TECHNICAL BULLETIN INDEX
Sorted by Bulletin Number
06/25/86

DATE: May 12, 1982
REVISION DATE: May 13, 1983
BULLETIN NO: 16:1
PRODUCT: 26-6001/2 Model 16
SUBASSEMBLY: AX-9241 FDC Board (Redesign)

FIG 1

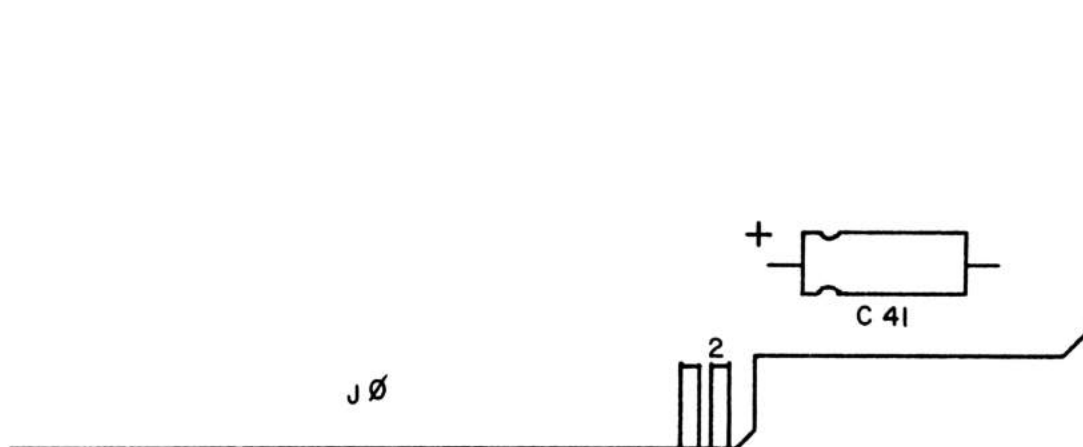
PURPOSE: To correct problem of C41 being installed backwards on early revision D Z-80 CPU boards.

DISCUSSION: On early Rev D boards C41 was installed backwards. This board and earlier revisions have had the (+) sign silk screened onto the board at the wrong end of the cap. The heavy trace attached to the capacitor on the component side of the PCB is ground and the positive lead of the cap should go to the other hole on the PCB.

PROCEDURE: Check all computers that are brought into the shop for this capacitor. If it is reversed, replace it with a new 33 mfd. cap with a voltage rating between 16 and 50 volts (Refer to Figure 1 for correct installation).

FIG 1

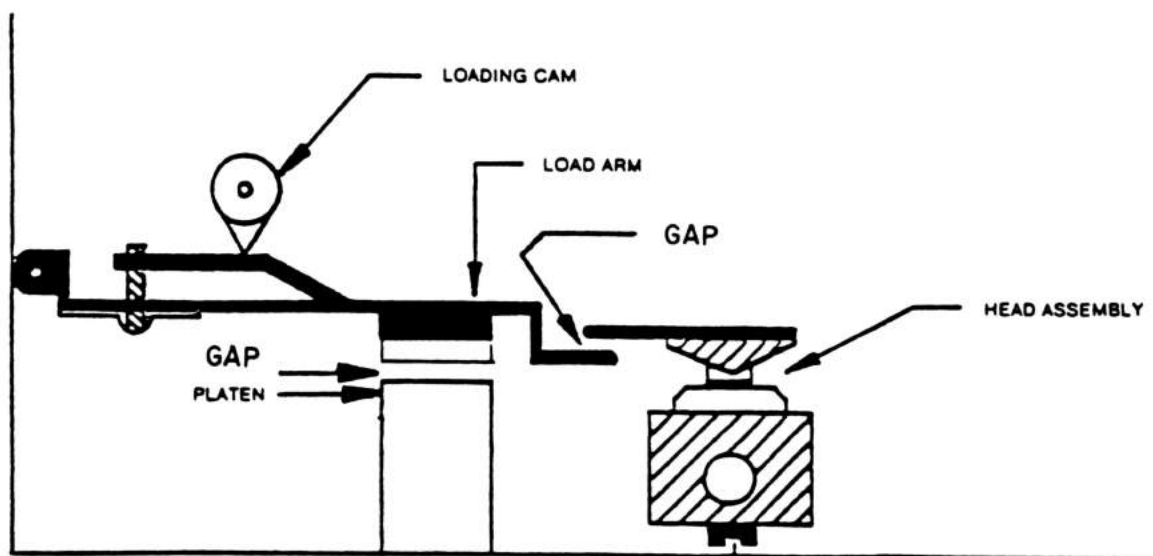
DISCUSSION: On some thinline drives the foam pad under the head load arm has been misadjusted so that the foam pad arm applies too much pressure to the diskette not allowing it to turn as it should. This problem can be solved by adjusting the head load arm. Also, on some drives the disk ejector has been pressing against the arm that presses the cone into the diskette. When this happens the diskette is not held as tightly as it should be. To correct this problem the trigger for the disk ejector can be adjusted.

The head load arm should be adjusted so that there is about a .015-.030 inch gap between the foam pad and the platen (Refer to Figure 1) with the door closed and no diskette installed. Once this has been adjusted there should be a visible gap between the foam pad and the platen with the door closed and no diskette installed. Check that the upper head does not rub against the head load arm with a diskette installed and that the upper head does not hit the diskette when the diskette is being inserted or removed.

Figure 1.

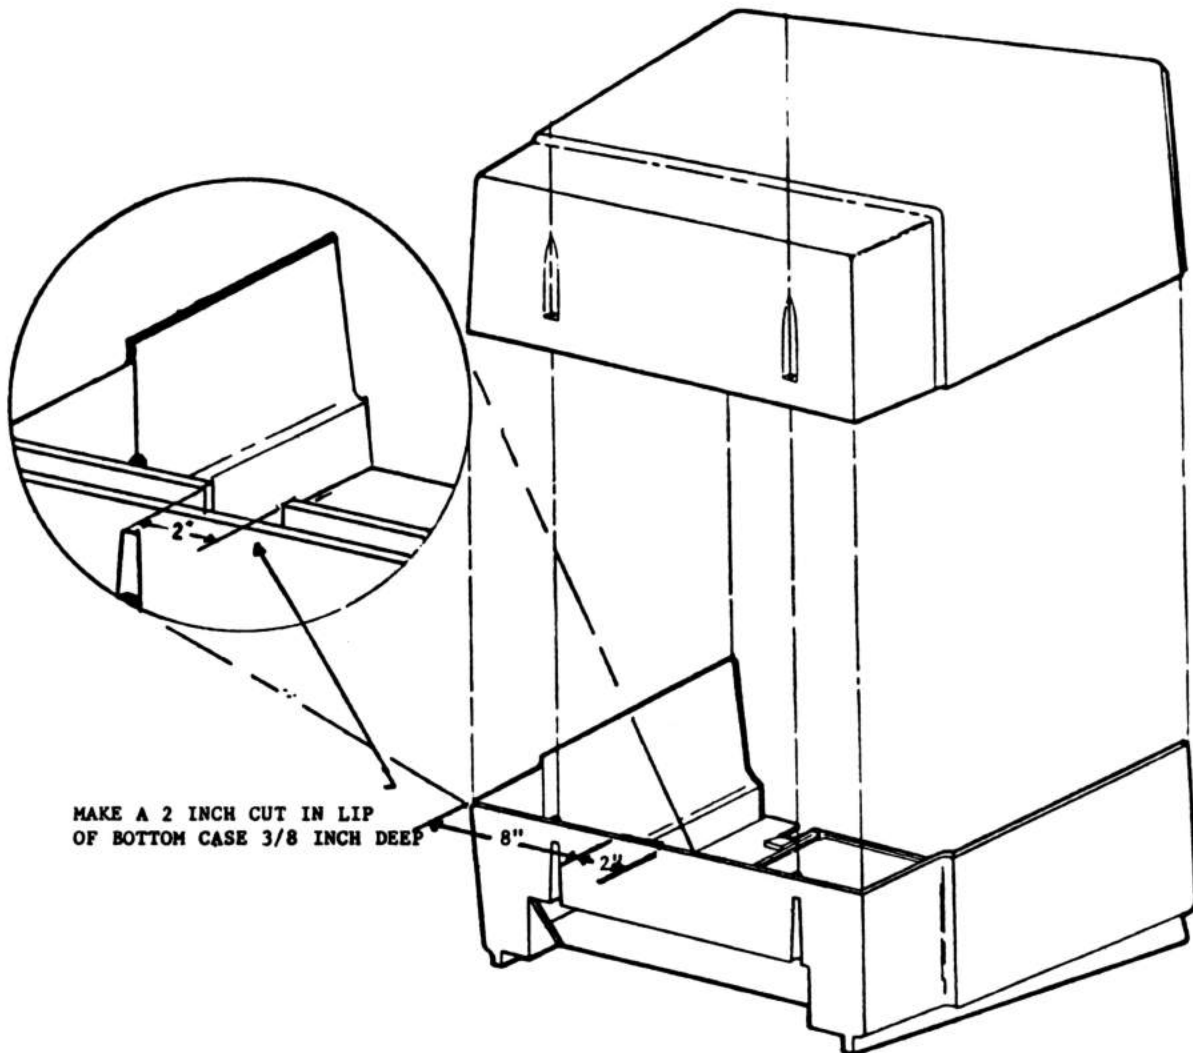
DISCUSSION: To install Multi-terminal Interface in the Model 16 you will have to modify the case bottom to allow external connection of the cables. Install the Multi-terminal Interface board in the #4 slot of the card cage so that the board will not interfere with any other boards or cables. If there is any other board in this slot move it to next available slot.

1. Remove case top to allow access to the case bottom.
2. (Refer to figure 1.) Measure 8" inches from left side (drive side) make a 3/8" inch deep cut, then measure 2" inches from first cut, and make another 3/8" inch deep cut. Cut away the two inches of plastic between the cuts. Clean the notch and make it smooth as possible.
3. Install Multi-terminal Interface board in #4 slot of card cage (**count from the Z-80 CPU board to the left.**) The proper slot positions should be filled as follows: (1) Z-80 CPU Board (2) FDC Board (3) Hard Drive Interface Board (4) Multi-terminal Interface Board (5) Video Board (6) 64K Memory Board (7) 68000 CPU Board (8) 16-Bit Memory Board, reading from right to left as you are facing the rear of unit looking at the card cage. If there is a board in #4 slot move all boards to the left leaving the #4 slot open for the multi-terminal board.

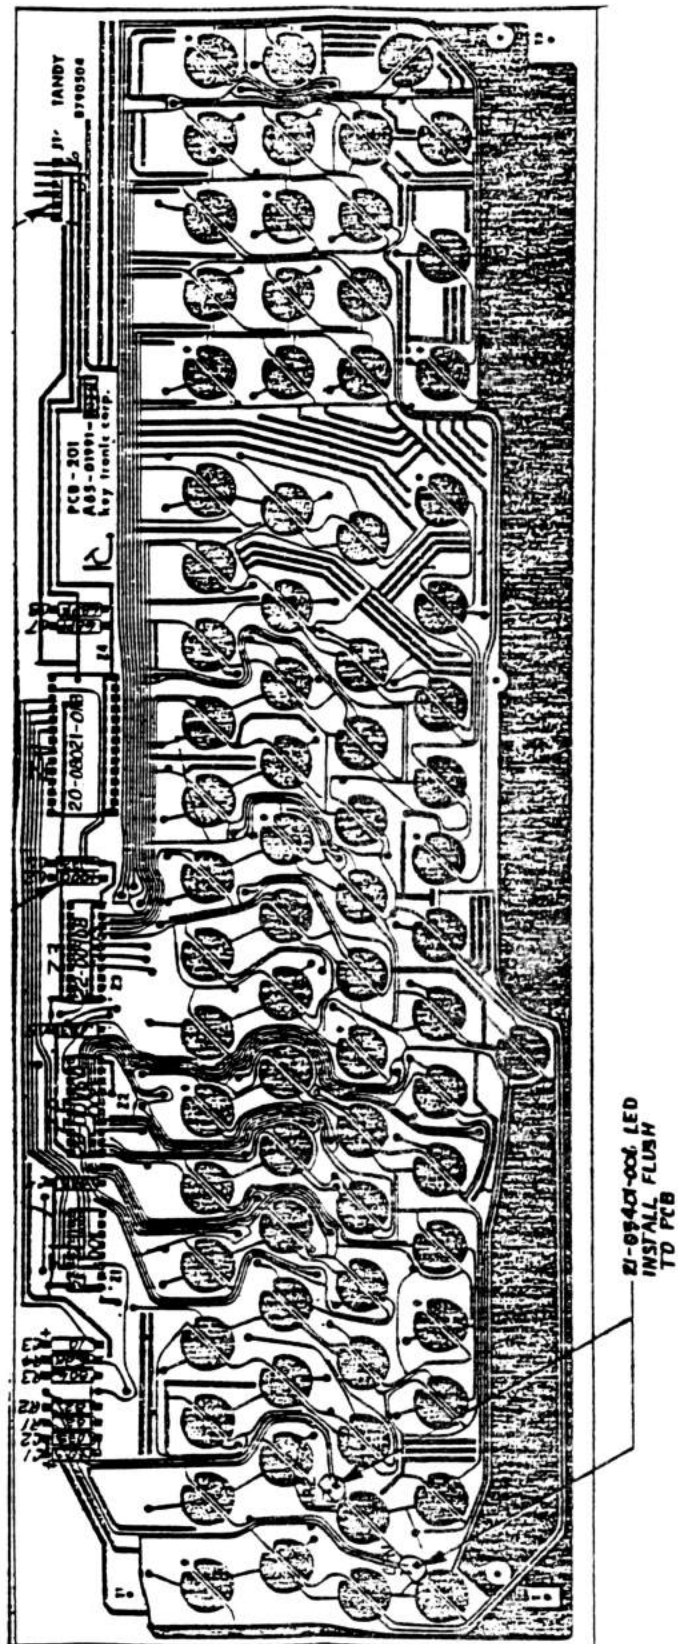
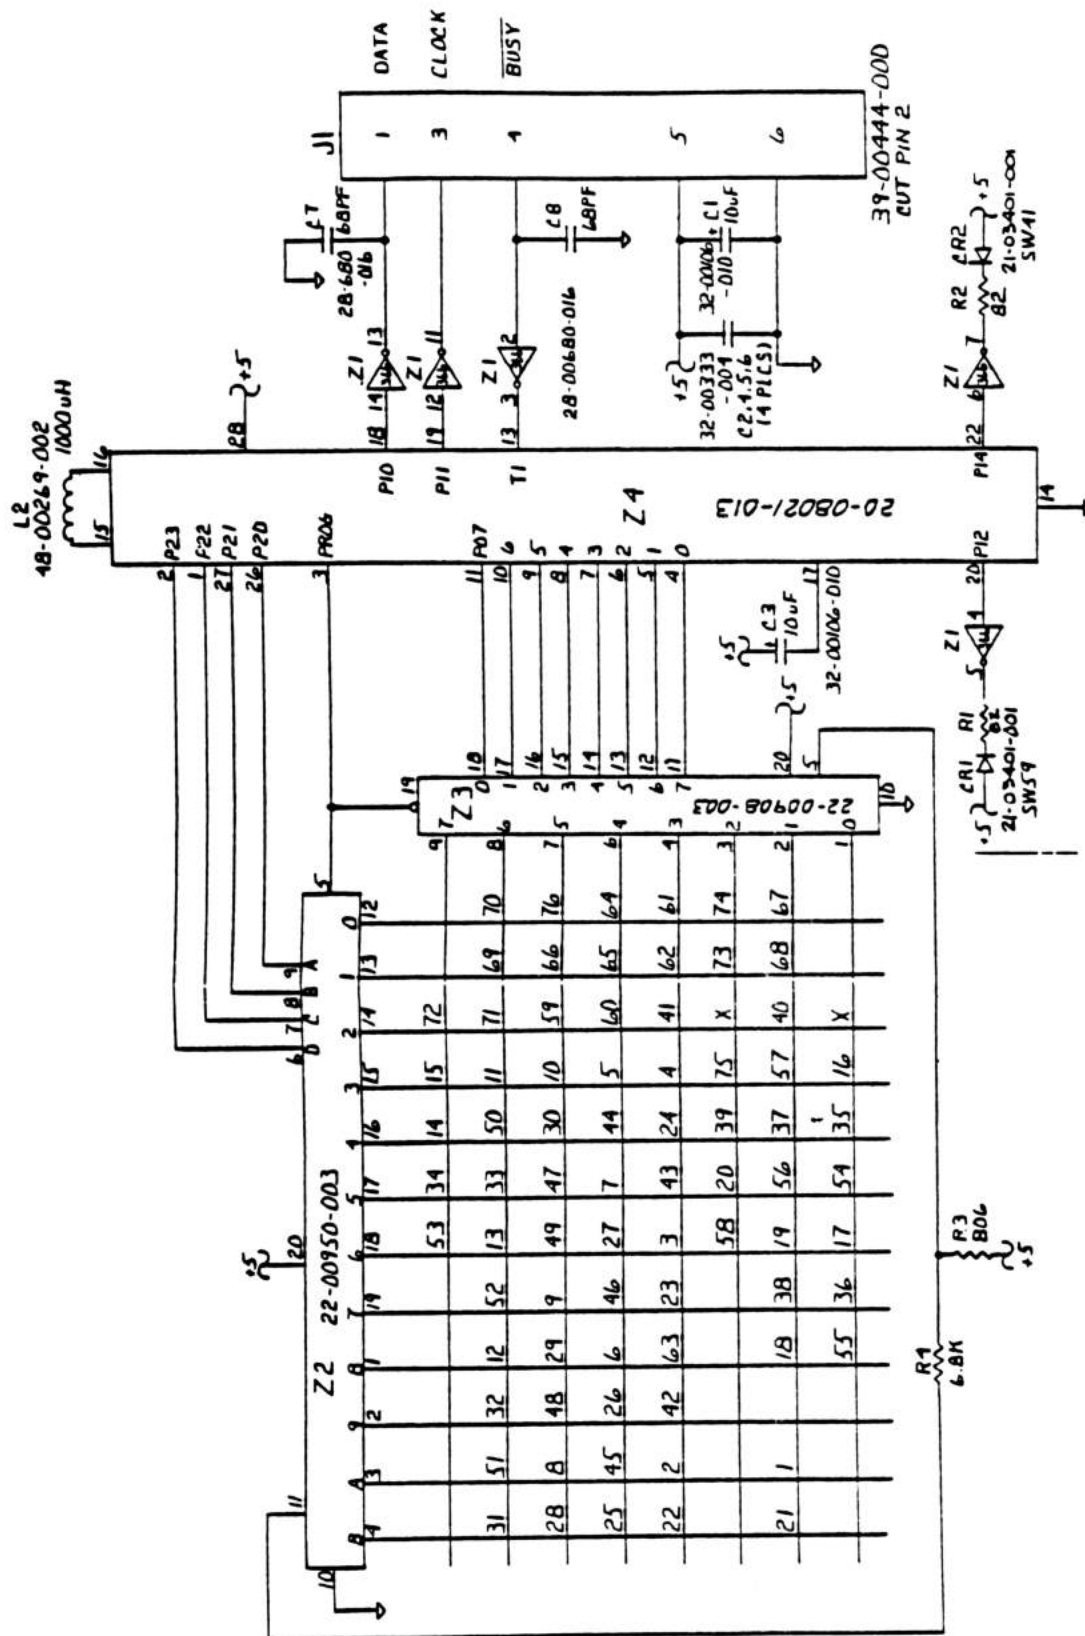
PURPOSE: Correct, and clarify the schematics on the model II/16 Key Tronic keyboards.

DISCUSSION: The Schematics for the Model II/16 keyboards in the Model II Technical Reference Manual are incorrect. Attached is the correct schematic and component location diagram.

SOLDER SIDE (LAYER 4)

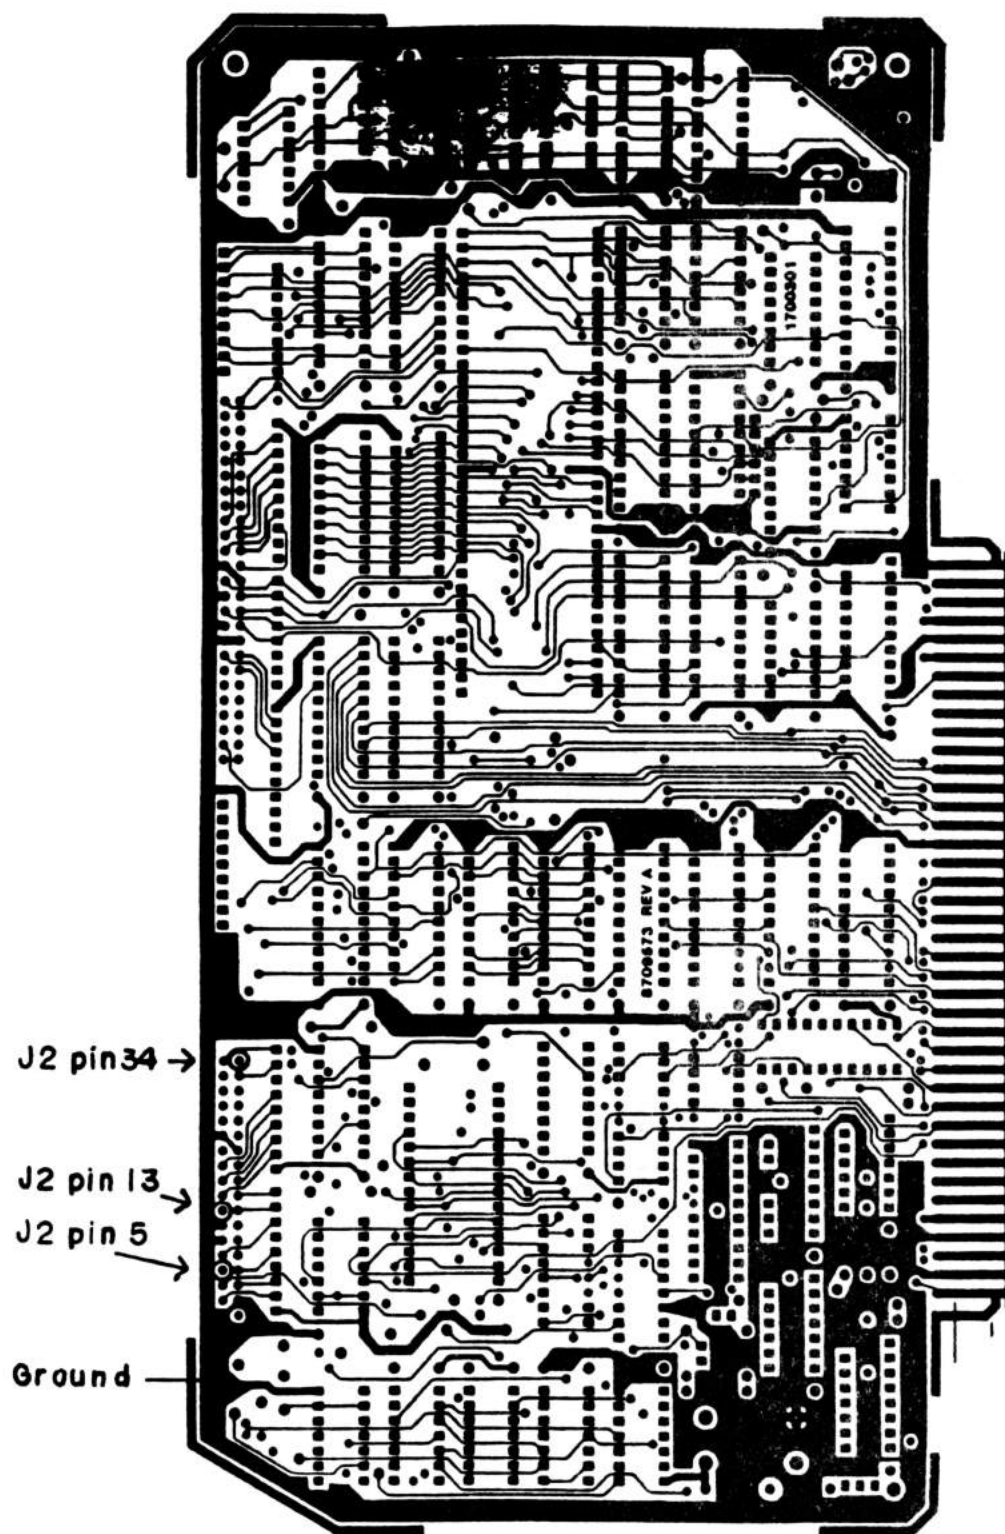
Due to an error in the artwork on early revision (Revision A) boards, a modification to insure good ground connections between the 68000 CPU board and associated memory boards is required.

Using wire wrap wire, install the following jumpers on the solder side of the 68000 CPU board:

- (1) Jumper J2, pin 5 to ground.
- (2) Jumper J2, pin 13 to ground.
- (3) Jumper J2, pin 34 to ground.

Ground may be found at the feed-throughs on the ground plane near J2 on the solder side on the board.

Figure 1.

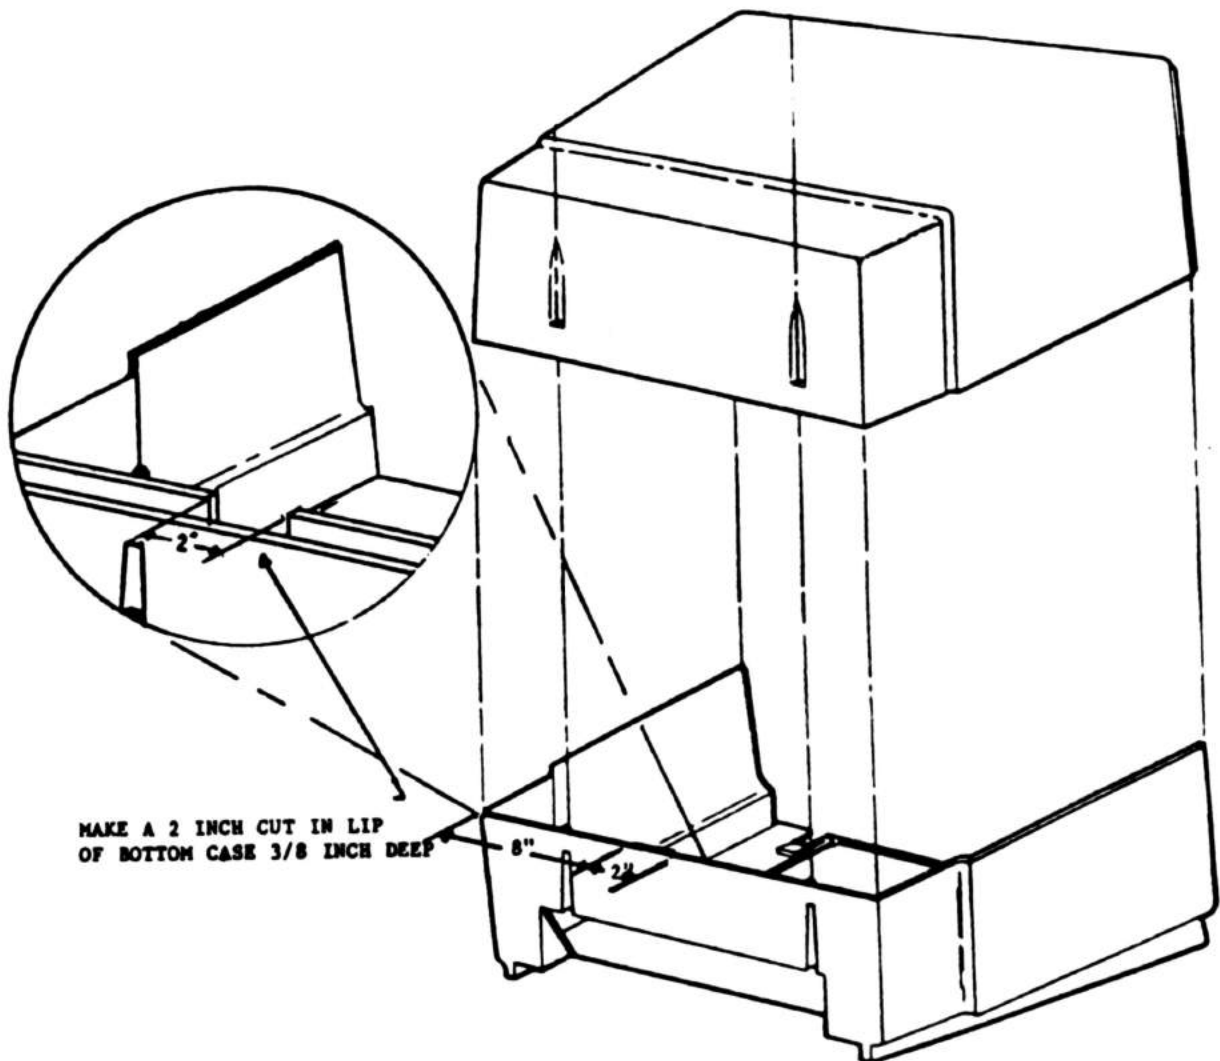
The mechanical alterations involve modifying the lower portion of the case to provide an exit for the Disk Cartridge System (DCS) interface cable, and adding a bracket to the card cage which allows the card cage retaining bracket to be used in a position which will not conflict with the cable connector on the DCS Interface board.

- (1) Remove the case top to allow access to the case bottom.
- (2) Refer to Figure 1. Measure eight (8) inches from the drive side (left side as viewed from the back) of the machine. Make a 3/8" deep cut. Measure two (2) inches further to the right from this first cut, and make another 3/8" deep cut. Cut away the two inches of plastic between the cuts. Clean the notch and remove all burrs.
- (3) Install the DCS interface board in the fourth card cage slot (viewed from the back, start with the **Z80 CPU board and count towards the left**). The extender bracket (Figure 2) will be installed as shown in Figure 3, on the side of the card cage nearest the floppy drive. The card cage bolt will pass through the hole in this additional bracket, and the end of the card cage retaining bracket will be held by the extender bracket.
